## 5.4. HEWITT MCU CARAVAN PARK L45 CAPTAIN COOK HWY

<b>REPORT AUTHOR(S)</b>	Jenny Elphinstone, Senior Planning Officer
<b>GENERAL MANAGER</b>	Nick Wellwood, General Manager Operations
<b>DEPARTMENT</b>	Development Assessment and Coordination
<b>PROPOSAL</b>	Material Change of Use For Caravan Park
<b>APPLICANT</b>	Fiona and Richard Hewitt c/o Studio Mango 457 Draper St Parramatta Park QLD 4870
<b>LOCATION OF SITE</b>	Lot 45 Captain Cook Highway, Port Douglas
<b>PROPERTY</b>	Lot 45 on RP835

That Council approves the development application for a Material Change of Use (impact assessment) for a Caravan Park over land described as Lot 45 on RP835, located at Lot 45 Captain Cook Highway, Port Douglas, subject to the following:

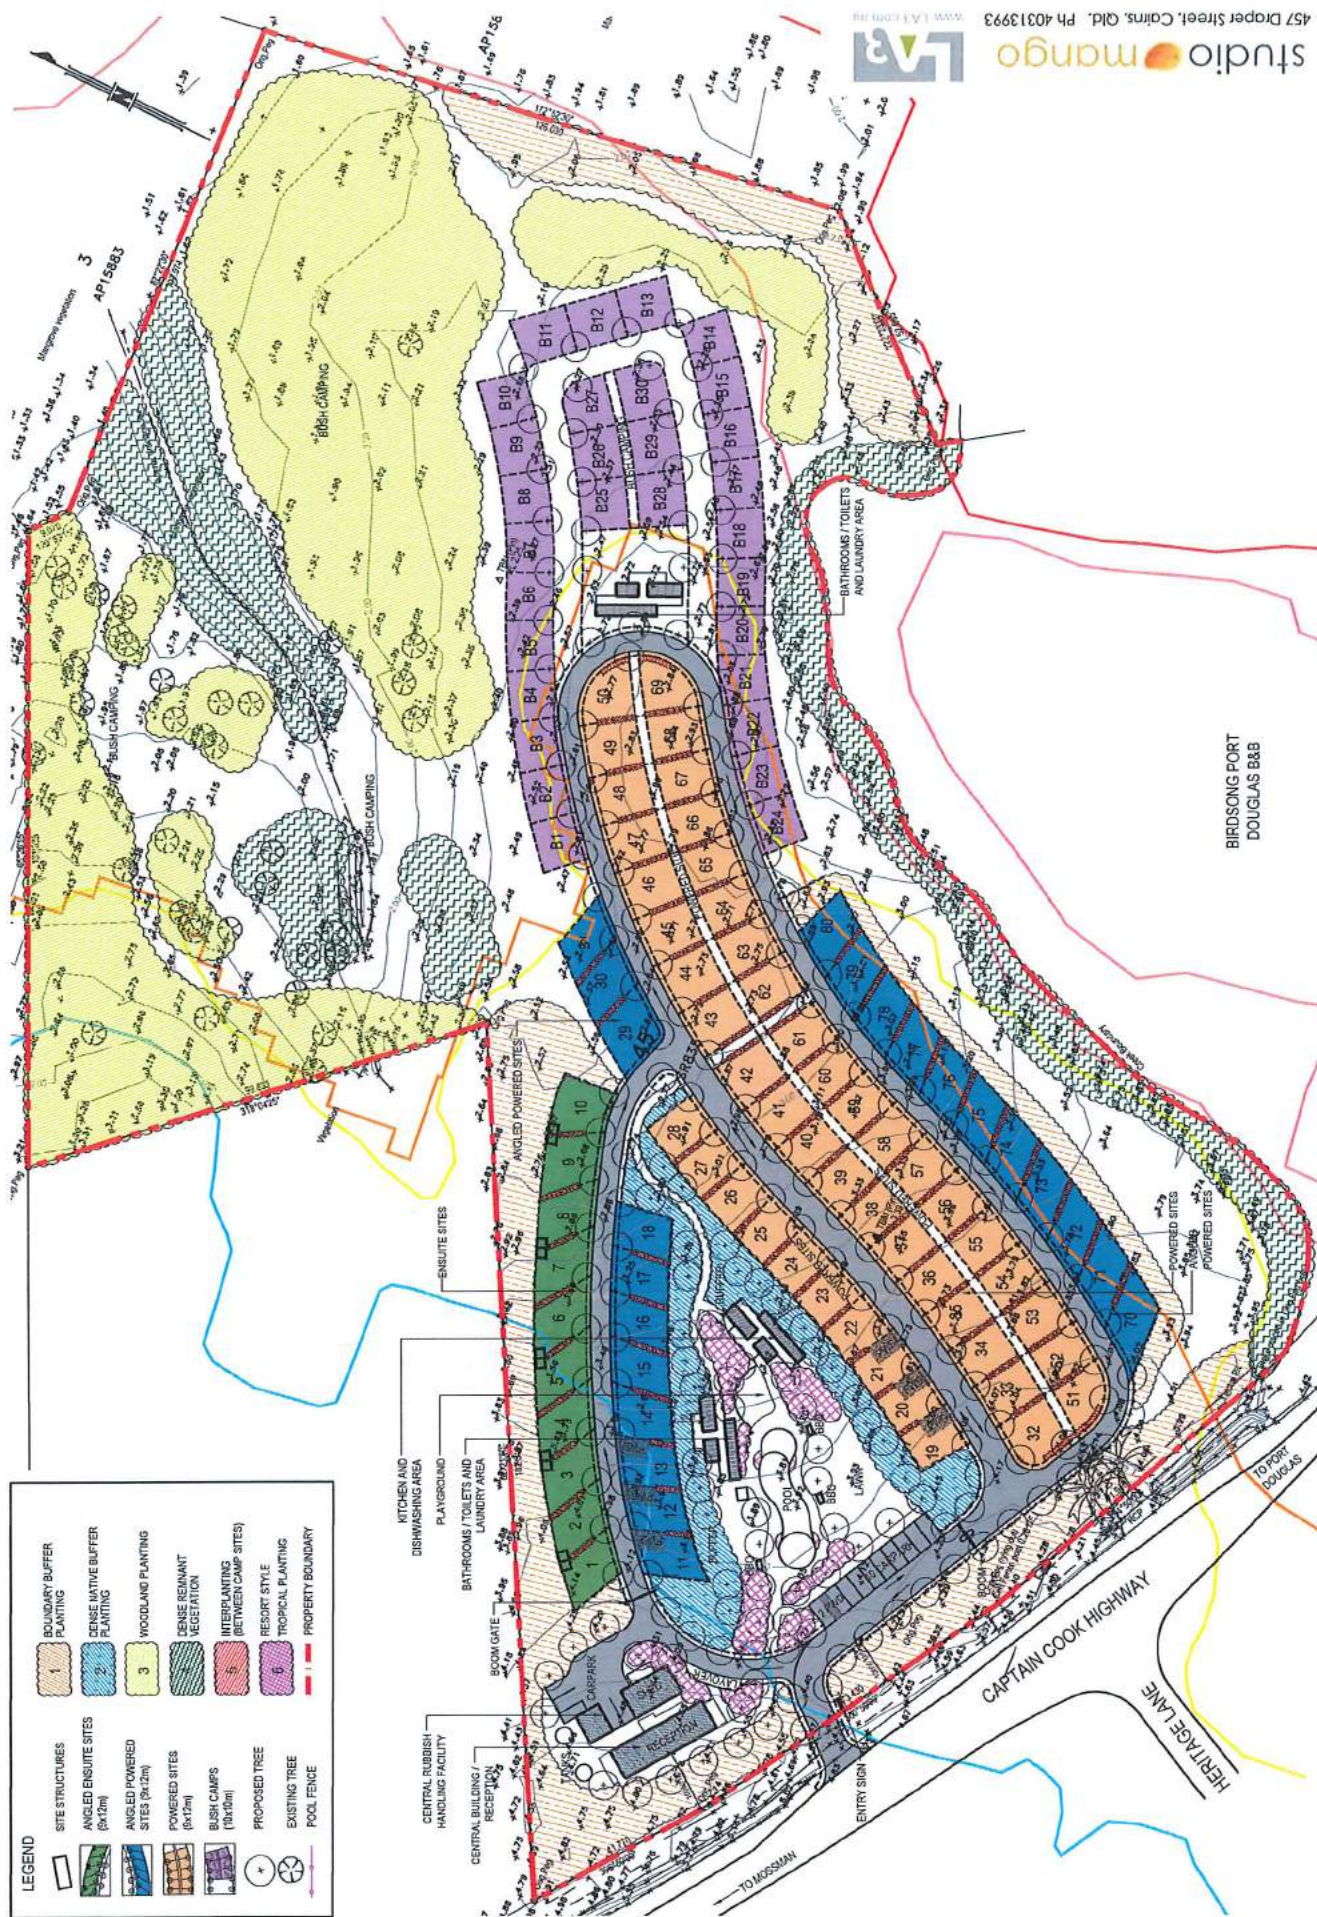
- 3. The proposed development must be amended to accommodate the following changes:**
  - a. remove wording of "bush camping" from the plan other than the designated individual sites (B1 to B30 inclusive) on Drawing L-05 Revision 3 dated 12 December 2017 and L-03 Revision 3 dated 12 December 2016;**

- b. camping sites are to be as per the general layout of Drawing L-05 Revision 3 dated 12 December 2017 and L-03 Revision 3 dated 12 December 2016 and not as per Drawing L-02 Revision 4 dated 24 January 2017.**

- h. relocate powered sites 32 and 51 on (Drawing L-05 Revision 3 dated 12 December 2017 and L-03 Revision 3 dated 12 December 2016 ) at least 30m from the front boundary. This is also in reference to sites 23, 34 and 53 (on Drawing L-02 Revision 4 dated 24 January 2017) to be located at least 30 metres away from the front setback; and**

The open areas marked as “bush camping” are not supported as they are too low in regards to storm tide inundation. These areas are to be deleted from the plan.

The planting of vegetation does not achieve sound attenuation from the Highway and concern is raised with the proposed sites Nos 32 and 51 and the plans indicate a row of trees to line the internal driveway, along the front of the site, in a regular pattern that does not reflect the informal growth in the area, notably the adjacent land to the north. To address a balance of desired scenic amenity, reverse amenity consideration and development of the land, conditions of the approval require incorporation of undulated mounds in the landscape buffer, relocation of sites 32 and 51 away from the front boundary and detail of the landscape plan.
